Grand Canal Multi-use Paths Phase I & II Public Input Summary: MAY 2019

The City of Tempe held two public meetings (May 8 and 11, 2019) to introduce the project to the public and seek input regarding the options for both Phase I and II. A video of the existing conditions was used along with a PowerPoint presentation and display boards to communicate the information.

Respondents were asked which of the two options for Phase I they preferred.

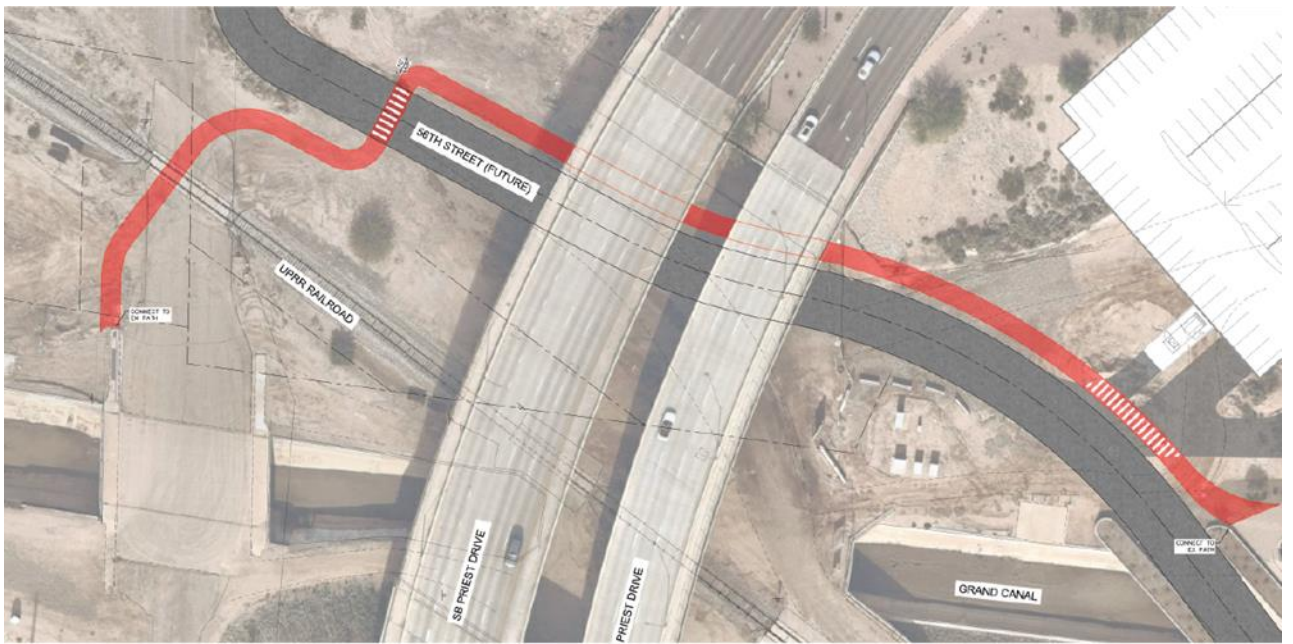
Respondents were asked why they preferred either the blue or red option:

1. Simplest
2. Stays away from possible alignment changes along 56th Street (52nd Ave?)
3. Only 1 street crossing. Seems safest alternative. No/less walking on 56th St.

4. Better "Flow", fewer streets crossed.
5. Safety
6. Less street crossing
7. Only one place to close the road, at a (lesser lower) used section of the road. This would not depend on what others do with that future road which could change.

8. Appears to be safer. Path only crosses auto traffic once not twice.
9. looks safer, better visibility
10. The blue option 'hugs' the canal more, which I think is better for wayfinding purposes. The blue route also eliminates another point of conflict/crossing that the red route has, namely crossing of the entrance into the parking garage.

11. Only one traffic crossing.
12. Less street/driveway crossing.
13. only one street to cross
14. One street crossing
15. less street crossings
16. No right angle street crossing of 56th Street. One street crossing vs two.

Respondents were asked to rank the four options shown in the diagram below:

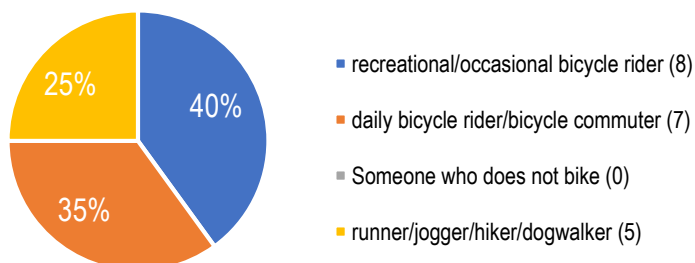
1. Purple and Red should be done at the same time since most of what is needed is ALREADY there.

Blue would be a good option pending more data on projected numbers of new residents along with current residents (both **business and** residential new construction). In addition I think we would need traffic counts done three times:

June 23-29 September 15-21 and sometime in the Spring during Spring training these dates would ideally collect the best range of traffic. After gathering that data would could make a better informed decision on the feasibility of that option.

Green is cool, but is the most costly and we might be able to better spend our money on other bicycle pedestrian upgrades in the city with a bigger need.

2. Blue is closest to Tempe Lake pedestrian bridge. Green is safe - seems like no direct access to street.
3. The blue alternative may not tie in to the Grand Canal best but it connects Tempe north of the Lake with Tempe south of the Lake via Hardy and a future Railroad bike path. It also makes "sense" of the Town Lake pedestrian bridge that currently is redundant with Mill & Priest bridges.

4. Lakeview makes the most sense for Downtown Tempe Town Lake accessibility Priest Road safety would benefit from the proposal from these improvements.

5. Green would be #1 if the funding could come in. It wouldn't be too steep and would get over the freeway. Red seems easiest because it's practically already in place. Purple also seems very easy to just move stripes, add paint. Center (blue) seems too steep, and goes to Washington like Red would. Both Red & Blue go to Washington. I use Lakeview Drive a lot more anyway, that's why it's my 1st choice. Also, there is hardly any traffic.

6. Another high priority project, critical to provide linkage between major regional paths. However, I don't understand why we are focusing only on joining the Rio Salado path with the Grand Canal path? The Crosscut Canal path also terminates in the general area, and lacks connectivity with either of the two other paths. I think a solution that links all three is necessary. For that reason I heavily prefer the Red design as it would be easily modified to include a link to the Crosscut canal.

Red: My preferred design, as this is how I currently connect between the two path systems. However, I dislike the current proposal which incorporates buffered bike lanes. The lakeview drive alignment should be used, however a multiuse path should be constructed on the shoulder of the road or in the road itself. Lakeview drive does not have

much vehicular traffic, but it seems foolish to use bike lanes as a means of joining major paths. Every linkage should be a 10' wide path, the same as the rest of the network. As part of this project the sidewalks on the south side of Curry and the east side of Mill can be widened to 10' to provide linkage to the crosscut canal path.

Green: This is obviously the 'bells and whistles approach' as it provides the least amount of conflict points with traffic. However, it's very expensive and I am concerned that placing the path connection so far to the west of the pedestrian bridge will limit the amount of people who use it.

Blue: My concern with this design is primarily that Center Parkway is heavily used during rush-hour times and that even with high visibility crosswalks there is too much potential for accidents between cars and bicycles. Additionally, it is unclear to me how the current design links up with the Grand Canal path. Will there be a ramp built down to the path from Center Parkway on the north side of the Grand Canal?

Purple: This shares concerns with Blue (too much potential for vehicle bicycle collisions) and Green (too far west from the pedestrian bridge).
